# UNITED STATES PATENT AND TRADEMARK OFFICE

APPLICATION NO.	FILING DATE	FIRST NAMED INVENTOR	ATTORNEY DOCKET NO.	CONFIRMATION NO.
10/564,582	01/12/2006	Celine Juliette Detecheverry	NL03 0878 US1	3317
65913	7550	05/27/2008		
NXP, B.V. NXP INTELLECTUAL PROPERTY DEPARTMENT M/S41-SJ 1109 MCKAY DRIVE SAN JOSE, CA 95131			EXAMINER BAISA, JOSE LITO SASIS	
			ART UNIT 2832	PAPER NUMBER
			NOTIFICATION DATE 05/27/2008	DELIVERY MODE ELECTRONIC

**Office Action Summary****Application No.**

**DETAILED ACTION**

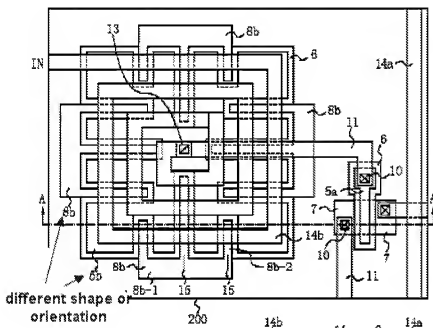
Applicant argues that the cited portion of Hiromoto appears to be a ground shield instead of a tilling structure. That is not correct.

Hiromoto discloses a layer of polysilicon pattern 5b in between the inductive element 14b and the substrate 1. Metal silicide 8b disposed on polysilicon 5b for the purpose of eliminating the noise generated by coupling of inductive element and the substrate 1. But since eddy current occurs in metal silicide layer lowers down the quality factor Q, Hiromoto introduces slits 15 to eliminate this problem. The slits created a finger-like structure electrically connected to a central strip. Similar to the specified structure of the applicant on Page 8, Lines 10-13. This structure pattern (8b, 5b), tilling structure, has a shape that substantially inhibits an inducement of an image current in the structure due to the current flowing through the conductor of the inductive element 14.

With regards to claim 4, Applicant argues that the cited portions 5b and 8b of Hiromoto are have the same shape and orientation. The Examiner disagrees.

Shown in this annotated Figure of Hiromoto (Figure 1) that 5b and 8b are of different shape and orientation.

With regards to claim 8, Applicant argues that Hiromoto reference does not correspond to aspects of the claimed invention directed to the tiling structures being a plurality of substantially triangular elements. That is not correct.

The tiling structure of Hiromoto as shown in Figure 1 or 3 shows each four corners(5b) having a shape corresponding to two substantially triangular shape elements (close to being a triangle) having a common side forming a substantially square shape. Annotated portion of Hiromoto's Figure 3 is shown below.
